PTP Timestamping clarifications_

IEEE 802.3 2018

Introduction

Figure 119-2—Functional block diagram

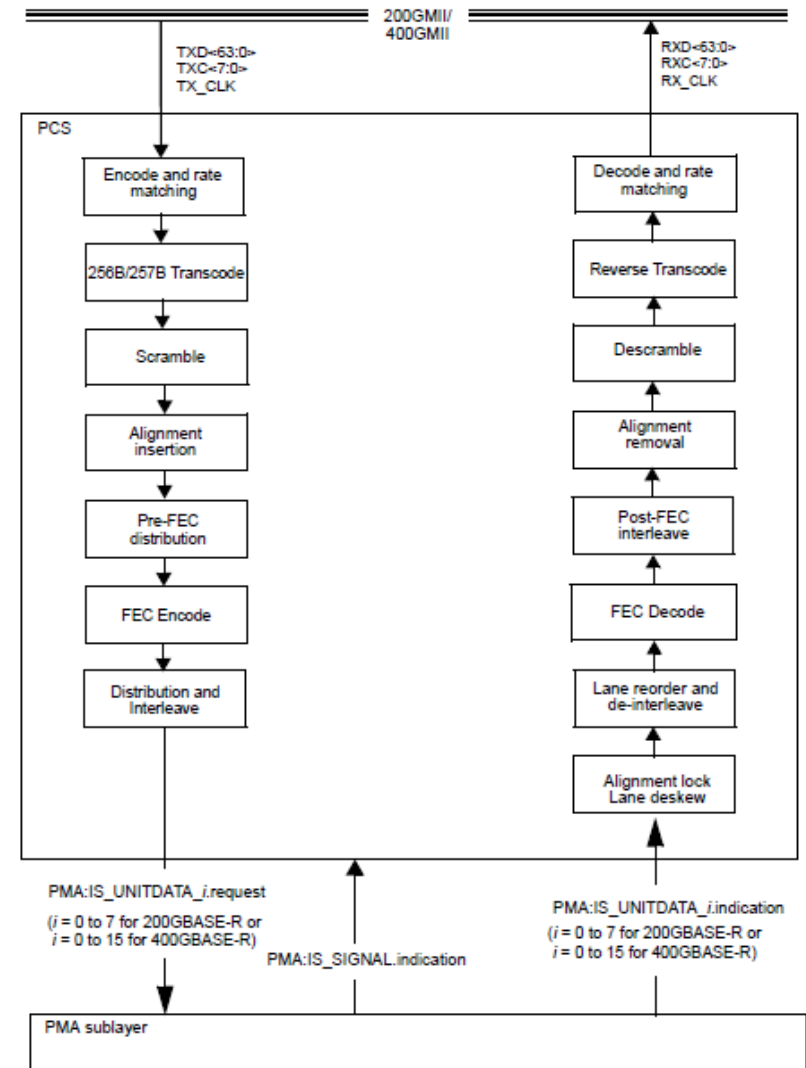
- Newer PHYs (200GBASE-R PHY is shown) are more complicated with respect to timestamping
 - Timestamp events are captured at the xMII
 - AM insertion/removal occurs between the xMII and MDI
 - The data shift resulting from AM insertion/removal creates new considerations for accurate timestamp transmission
 - There are different allowable methods for creating the bandwidth needed for AM insertion

- Figure 119-2 (see slide 3) shows a Tx functional flow of the gRS (where timestamps are inserted) followed by rate matching followed by AM insertion
 - Accommodating AM insertion is one of the potential reasons for rate matching
 - Rate matching is typically performed by Idle insertion/removal
- Strict adherence to the functional flow of Figure 119-2 implies that the timestamp event captured at the xMII will be shifted by the AM and Idle insertion/removal process, thus creating an inaccuracy for which (unlike FEC) there is no guarantee that the Rx processes will cancel it out in the same location of the received bit stream
- However, 802.3 has a long established principle of recognizing implementations as being compliant as long as the device output bit stream is the same as if the process described in the standard had been applied

Figure 90-3—Data delay measurement

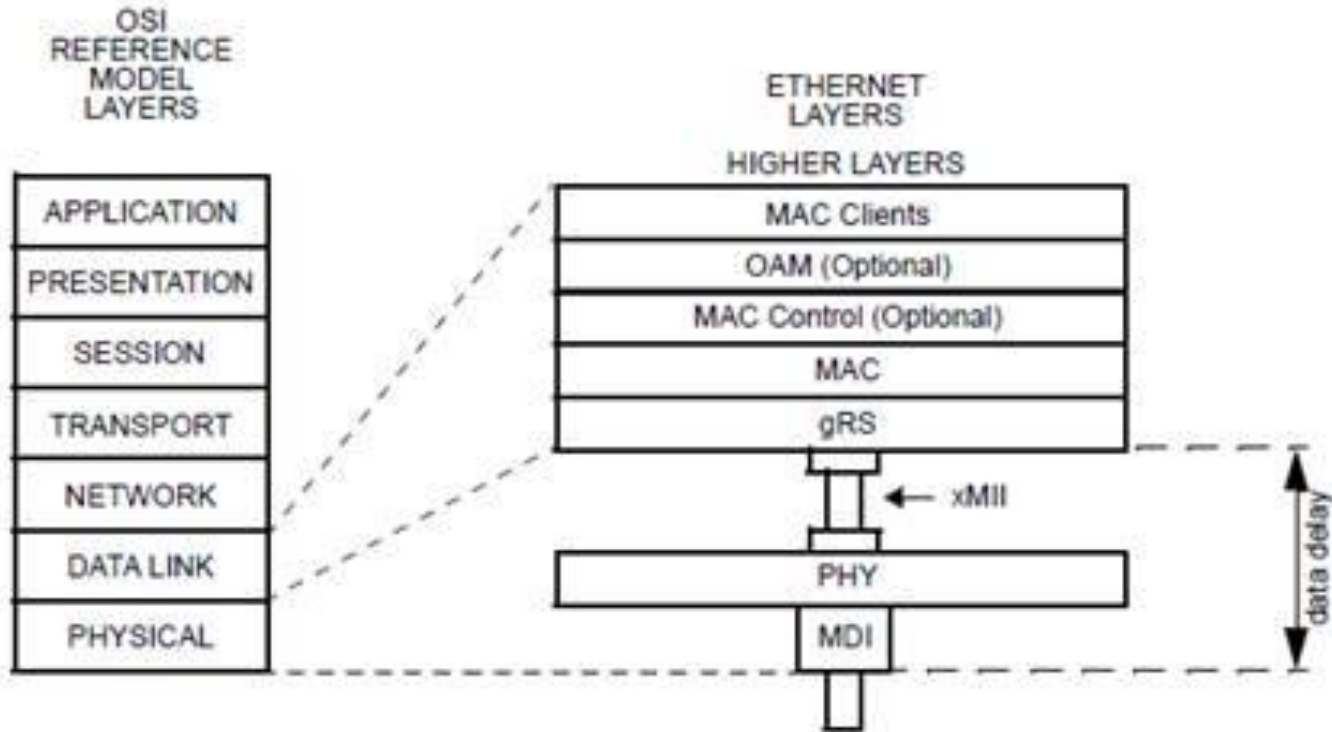
- For a multilane PHY, after deskew delays are accounted for appropriately and since timestamping is at the PMD, would the timestamps be the same regardless of which lane the message's timestamp reference point is transmitted on (or received on)?
 - Since all lanes are transmitted at the same time and received at the same time (after deskew) at the PMD, it would seem this is a valid conclusion.

- However, this means that PHY data delay (between xMII and PMD, as per Figure 90-3 above) is not the same for every lane because the PMD-to-xMII multiplexing delay (for Rx) and xMII-to-PMD demultiplexing delay (for Tx) is different for each lane (as shown in Figures 82-3 and 82-4 below). In the Tx direction, codewords going to lane 0 have the most delay and codewords going to lane 3 have the least delay. In the Rx direction, the opposite is true. To capture an accurate timestamp at the xMII (as per the 802.3 model), the lane-based intrinsic delay must be included as part of the PHY data delay.
 - Was this the intent?

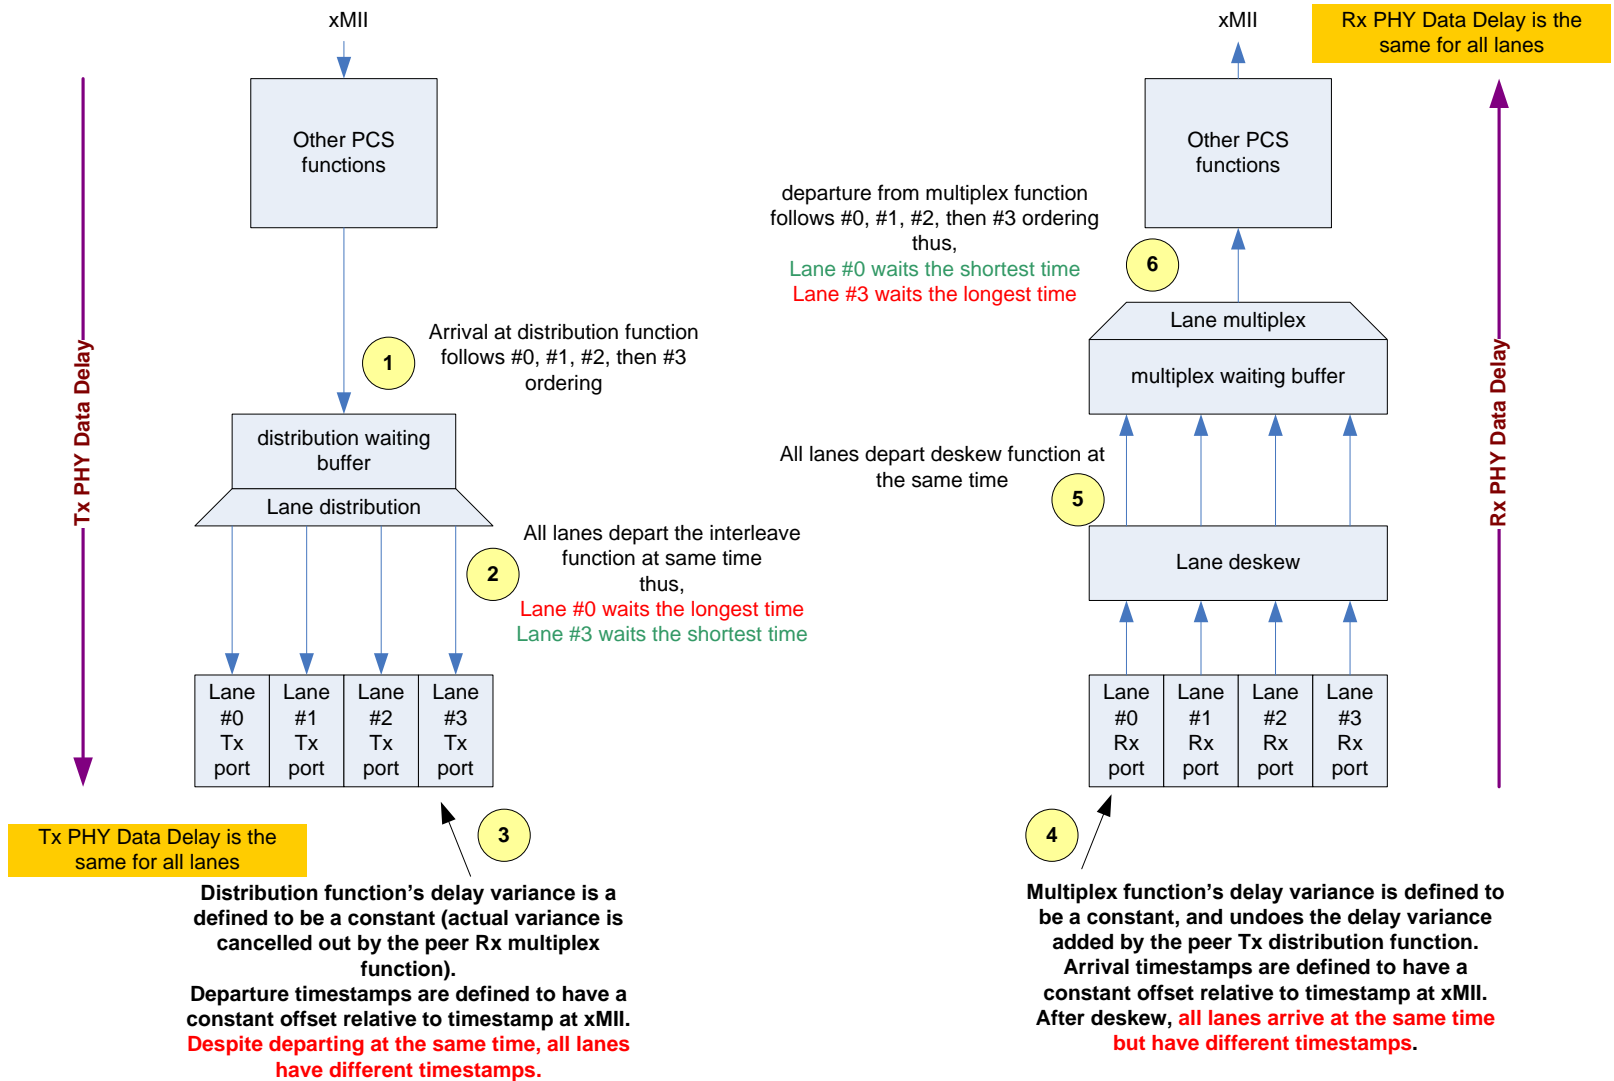
- These multilane PHY data delays could also be designated to be a constant value for all lanes if the principle that is used for FEC's varying intrinsic delays is applied for multilane's multiplexing/demultiplexing varying intrinsic delays.
 - i.e., the Tx intrinsic demultiplexing delay is balanced by the Rx multiplexing intrinsic delay, making the aggregated demux/mux delay a constant.
 - Was this principle on anyone's mind when the multiplane PHY function was defined?
